TO: Ann Clevenger, Planner  
Oakland Planning Department  
FROM: Leal Charonnat, Architect  
Project Address: Edward Xiao Residence -  
6754 Aitken Drive, Oakland, Ca 94611  
Design Review No: 14268 (Oct 10, 2014 posting)  
Project: New Single Family Dwelling  
SUBJECT: Design Review Response Comments

Design Review No: 14268 (Oct 10, 2014 posting)  
Project: New Single Family Dwelling  
SUBJECT: Design Review Response Comments

FIGURE 1.1: PROPERTIES ELIGIBLE FOR VIEW PROTECTION

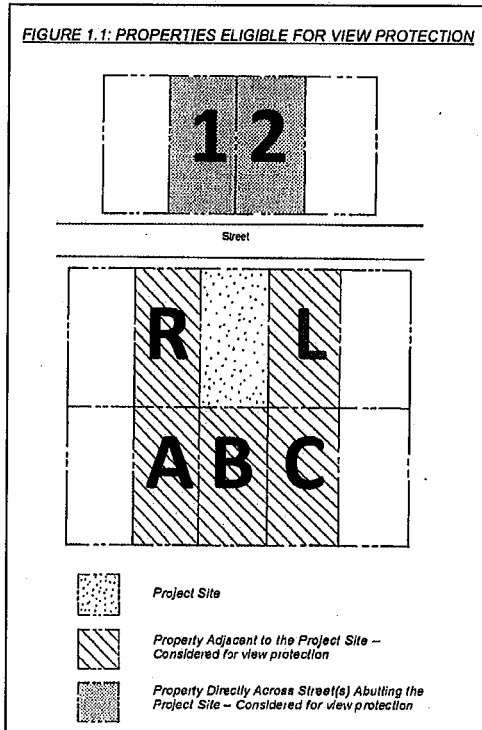
**Criterion 1: Views** - A project shall make a reasonable effort to maintain the most significant views from primary living spaces of existing residences on lots in close proximity to the project site. View protection is considered for views that are located within view corridors, subject to view protection limitations.

**RESPONSE: Eligible Properties (from figure 1.1)**  
**Properties 1 & 2** - These properties are located below street level. This project has no impact on their view corridors.

**R - Neighbor on right** - This house is situated on a highly excavated lot. There are no windows facing the common property line. As such, this house has no major view corridor across the project property.

**L - Neighbor on left** - This house is situated on a highly excavated lot. There is one major view window - a "green house-type" facing the common property line. The project side yard setback almost twice the required amount. The neighboring property has a 60-degree view angle across the project property. It should be noted that that view is also through an existing oak tree that is to be retained. (see SITE PLAN AT GRADE)

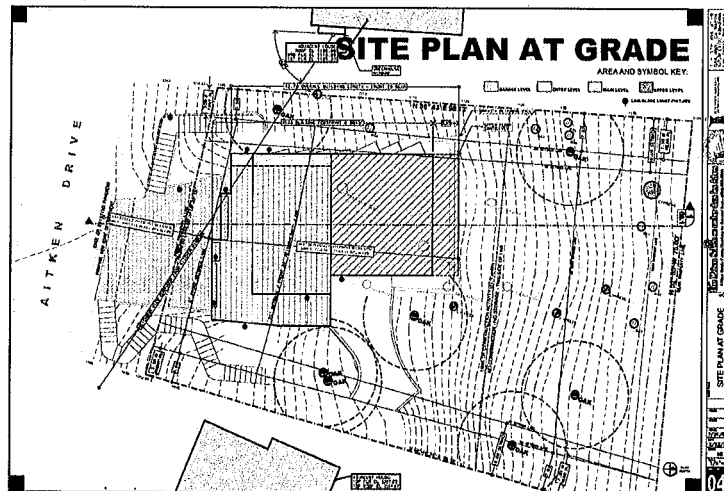
**Criterion 2: Solar Access** - A project shall make a reasonable effort to minimize solar access impacts on actively used outdoor or indoor areas of abutting residential properties.

The rear wall of the project matches closely the rear wall of the adjacent property. (See site plan. Note - outline of existing neighboring houses were established by the property survey.)
